To: Dan Fisk, Paramounte Engineering
From: Pat O'Mahony, Associate Planner; 910-341-0189
CC: File;
Date: 7/8/2020
Re: East & Mason TRC Rev. 1

Site Plan Comments (Pat O'Mahony, Planning):

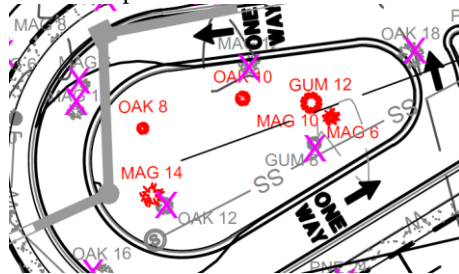
1. Ensure tree protection is shown around all trees located within perimeter buffer area:

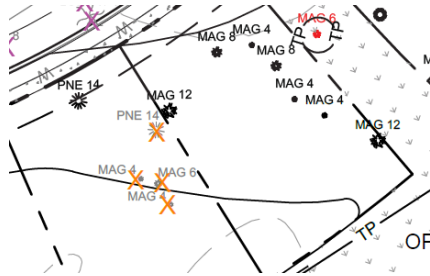
2. Show tree protection:
